Cree® XLamp® XB-D LED Product Change Notification

PCN Reference Number: CREE-PCN-0770

Date Issued: March 21, 2019

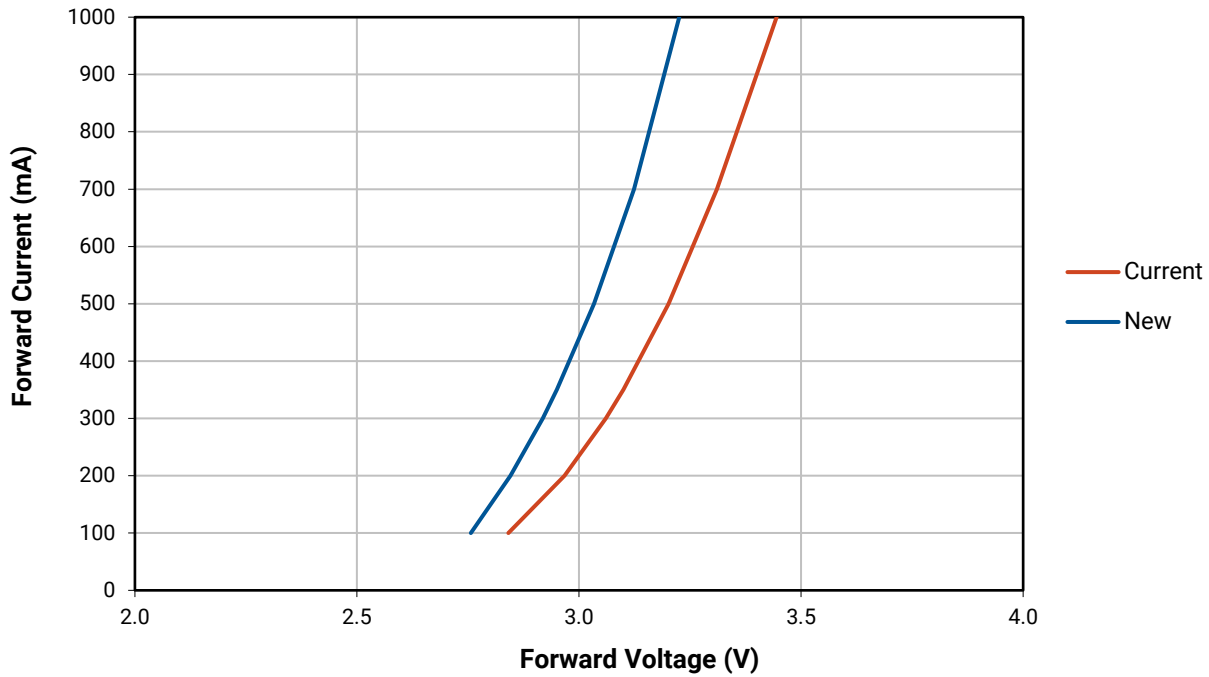
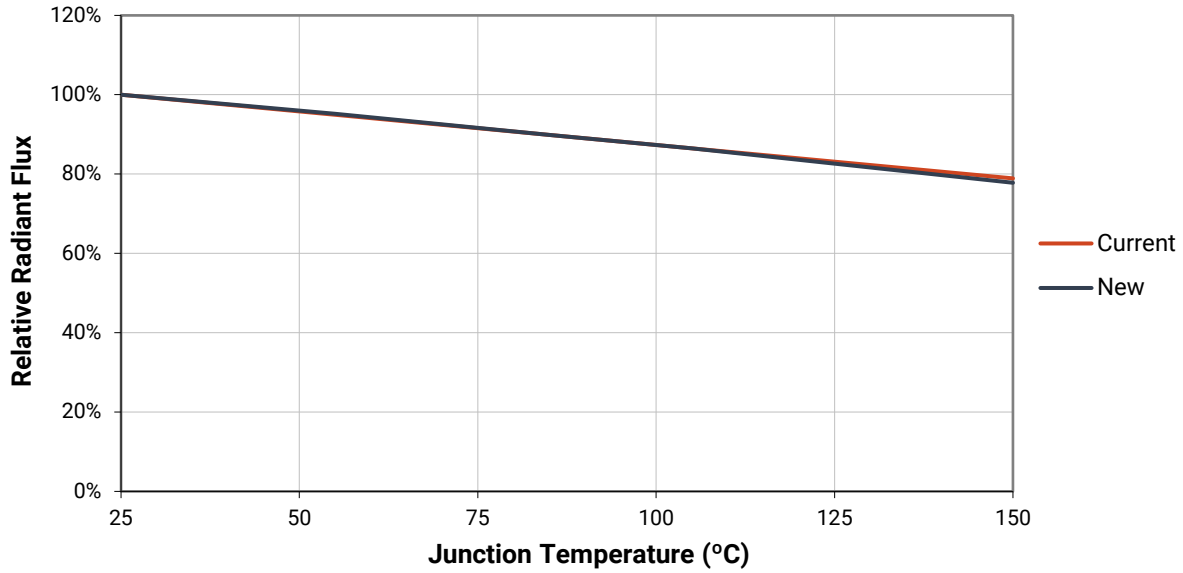
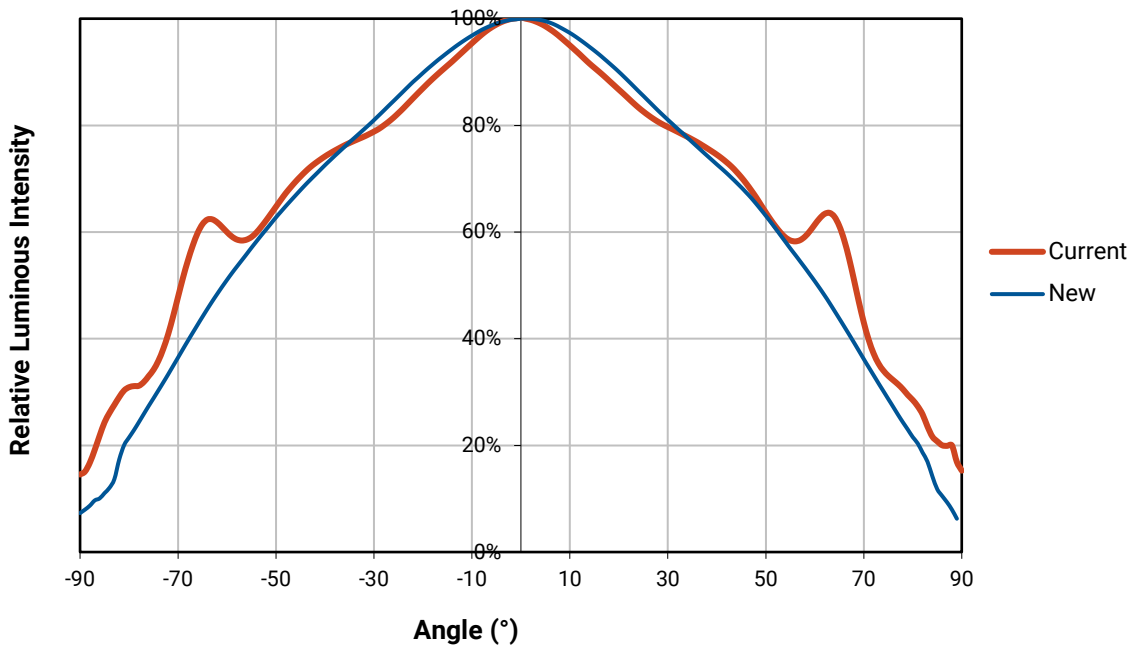
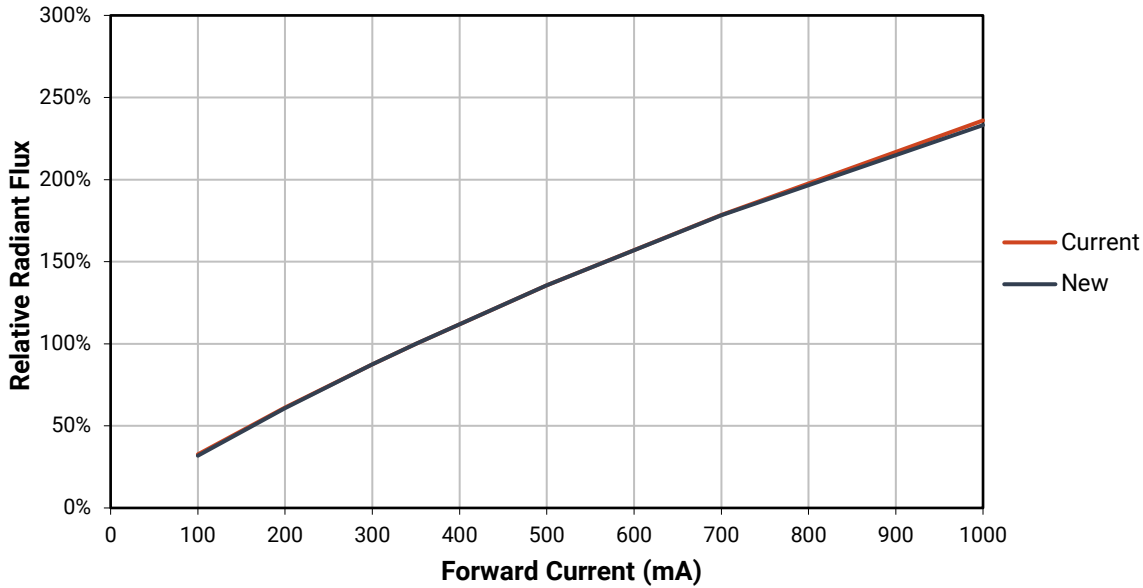
This change results in improved performance.

- The radiant flux is increased.
- The forward voltage is lower.
- The typical spatial distribution pattern is smoother.

Cree is updating the XB-D data sheet to show the performance of the new parts. The following graphs show the change in performance.
